Service Bulletin

SUBJECT: Service Update for Inventory and Customer Vehicles
Turbo-to-Exhaust Manifold Joint May Relax
Expires with Base Warranty

MODELS: 2013 Cadillac ATS
2013 Chevrolet Malibu
Equipped with 2.0L Engine (LTG)

3268362

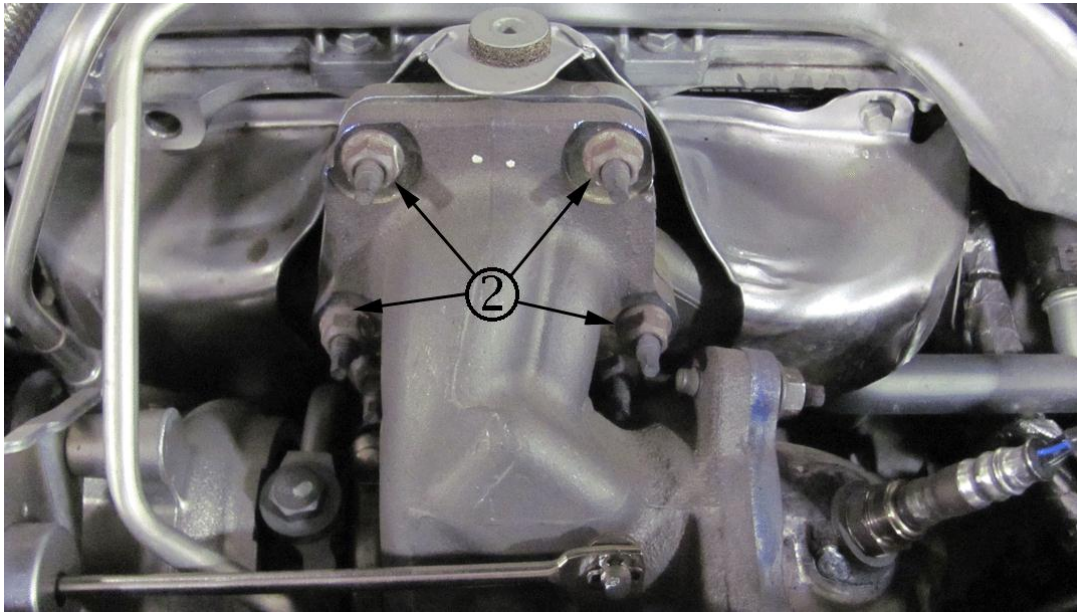
This bulletin provides a service procedure to tighten all 4 exhaust manifold bolts on **certain** 2013 model year Cadillac ATS and Chevrolet Malibu vehicles, equipped with a 2.0L engine (LTG). The ring gasket may be pinched between the flanges on the inside diameter of the joint leading to a visible gap. As the pinched part of that gasket relaxes, clamp load is lost at that stud location.

2. Locate the turbocharger exhaust heat shield (1).

3. Remove the turbocharger exhaust heat shield. Refer to *Exhaust Manifold Heat Shield Replacement (LTG)* in SI.
